Naylor Farms Geology Hearing

IDWR Permit No. 87-10022 in the Name of Ralph Naylor Farms, LLC

Testimony by William J. Elliot, PE, PhD

In Support of Dr. Lois Blackburn, Intervenor

Figure 2. Stream network and approximate suggested basin borders from Exhibit 11b

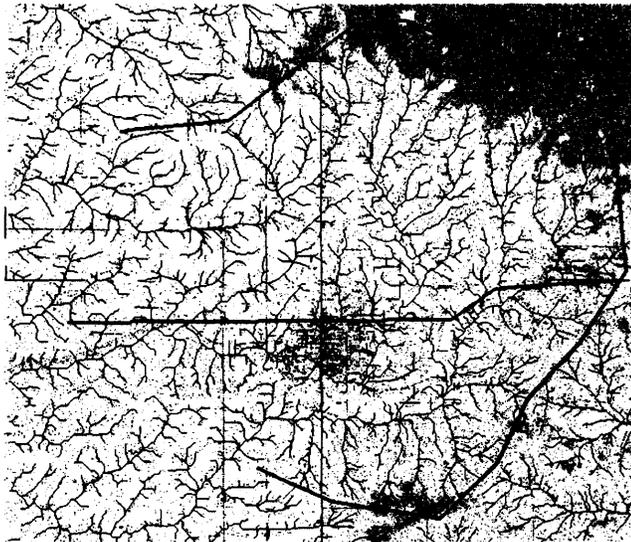
Exhibits 11a and 11b develop a theory that there are distinct sub-basins separating the proposed Naylor development site from the Moscow-Pullman well sites. Arbitrary lines were drawn between the Moscow Sub Basin and the Naylor Sub Basin shown in Slide 26 in Exhibit 11b. The dividing line shown, however, is crossed by numerous streams

including the South Fork of the Palouse River in the East, and Paradise Creek in the center, of this basin division line (Figure 2). Clearly there is a surface water connection between these two sub basins at a minimum. There are no subsurface data presented in the Naylor exhibits to support the claim the two sub basins are hydrologically disconnected, only some vague geologic discussions from maps and observed landscaping in the area. Generally, in this area, surface channels tend to flow in the same direction as underlying geologic features, so it is likely that if surface water is crossing between these two “basins”, that there will be substantial groundwater links as well. The conclusion drawn in Exhibits 11a and 11b, that the “Naylor Sub-Basin” and the “Moscow-Pullman sub-Basin” are not accessing the same water is not valid. **Hence, the IDWR (2004a) Conclusions of Law number 3, that suggests little interconnection, is not correct. There is unquestionable surface connection between the Naylor Site and the cities of Moscow and Pullman, and quite likely a subsurface connection as well.**

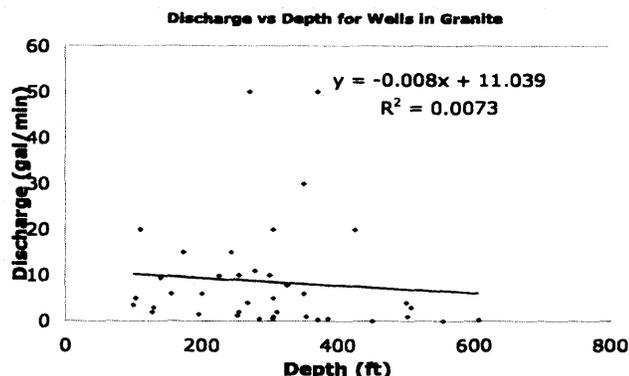
well discharge and the depth of the well from 38 granitic wells within three miles of the Naylor site, confirming this correlation. Deeper wells do not produce more water, and in fact, Figure 6 shows that they are more likely to produce no water. Granite formations decompose with weathering into decomposed granite (DG). Decomposed granite aquifers tend to be more shallow than wells into unweathered granite. The makeup of decomposed granite is both sand and clay particles, and so the hydrologic properties of decomposed granite aquifers can vary widely, with the well logs estimating discharge in DG from less than 1 to more than 10 gal/min (Figure 7).

Figure 6. Discharge as estimated on well logs vs depth of well for 38 wells drilled in to granite aquifers within three miles of the Naylor site. wells (e.g. Well A.6). Although well logs were not available, the University of Idaho also abstracts water from these layers (Kopp, 1994). The letter from Naylor Farms dated April 12, 2004, on page 14 states "our intent is to drill a well about 470 feet deep, thus avoiding the conflict with existing nearby farms." The well logs clearly show that such a well will not avoid conflict as there are many wells pumping from the sediment layers below the Wanapum basalt, the intended source of the large groundwater abstraction for the Naylor site. Major pumping from these sediment aquifers will likely have major impacts on the 20 other wells pumping from these same layers. **Hence, the IDWR (2004) Conclusions of Law Number 4, that states "Naylor Farm's (sic) pumping will essentially be from a separate source of water and will not reduce the quantity of water available to existing wells in the area" is not valid.**

Figure 8. North-South profile through the proposed Naylor well site.

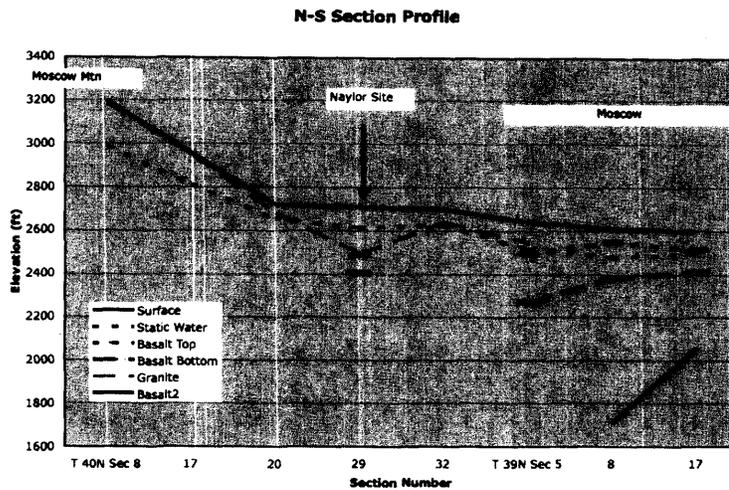
The average elevations by section of the underground properties for a North-South profile are shown in Figure 8. There was only a single well in Section 32, and it was in the southwest corner of the section. From the well map (Figure 4), it is apparent that in this vicinity, in the next section south, section 5, there are a number of wells in decomposed granite in the western part of the section, whereas there are a number of wells in basalt in the eastern part of the section. Hence the perception that the granite layer is above the

basalt layer. The two dimensional nature of Figure 8 is not adequate to display all of the complexity of the aquifers in this area.

There is a major inconsistency between the well log data and the Naylor Test hole results in the depth to granite. Concerns were expressed about whether the test hole reached 470 feet in Section 3.3 of this testimony, and the well log information does not confirm this depth. Table 2 presents the depth to granite and the distance to nearby wells in the vicinity of the Naylor site. Figure 10 shows the location of the wells with respect to the Naylor site. Table 2 shows that generally, the closer the wells were to the Naylor site, the smaller the depth to granite. These data suggest that the likely depth to granite beneath the Naylor site is probably less than 300 ft, confirming the concerns about depth of drilling expressed in Section 3.3.

Figure 11. Wells in the vicinity of D Street in Section 8

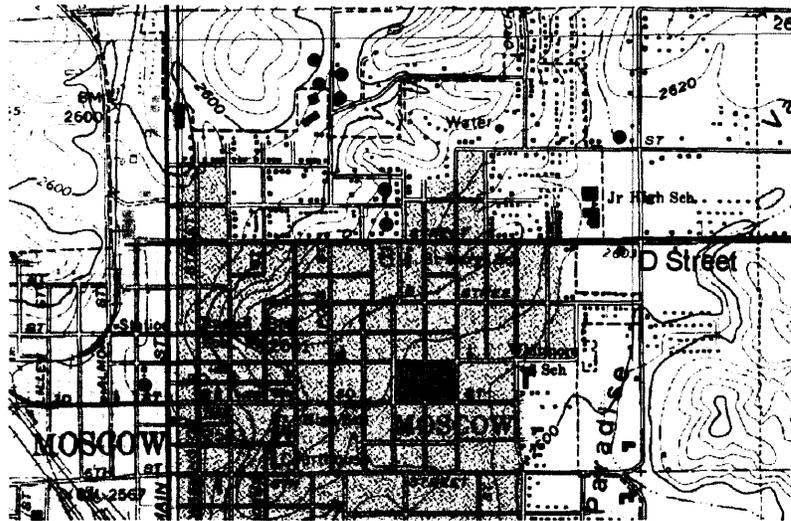
One of the key points made in the Naylor application was a “D Street Ridge” (Exhibit 13a), as this ridge would prevent any water abstraction at the Naylor site from impacting Moscow municipal wells south of D street. Figure 11 shows the location of D Street, and all of the wells that were on file at IDWR (2005) from Section 8 (T39N R5W). If this significant ridge exists, it should be readily apparent in the well logs for wells in the vicinity of D Street.

D Street is an east-west road that bisects Section 8 (Figure 11). Table 3 records the summary for all of the well logs for Section 8. It is clear in Table 3 that there is no indication of any material other than overburden closer than 40 ft from the surface. Below the overburden on all wells is a basalt layer, and no indication of material found only in Kamiak Butte as stated in Exhibit 13a. As stated in Section 4.1.2, basalts have a high degree of anisotropy, with horizontal hydraulic conductivity much greater than vertical conductivity, and water preferentially flows through basalts in the direction that the original basalt flow occurred. In this area, the basalt appears to have flowed from south to north (Figure 8), or in this case, north toward the Naylor site from Moscow. These results simply confirm what has been stated previously (Section 4.1.2), that any significant increase in pumping from the basalt layers north of the city will likely dewater all of these wells.
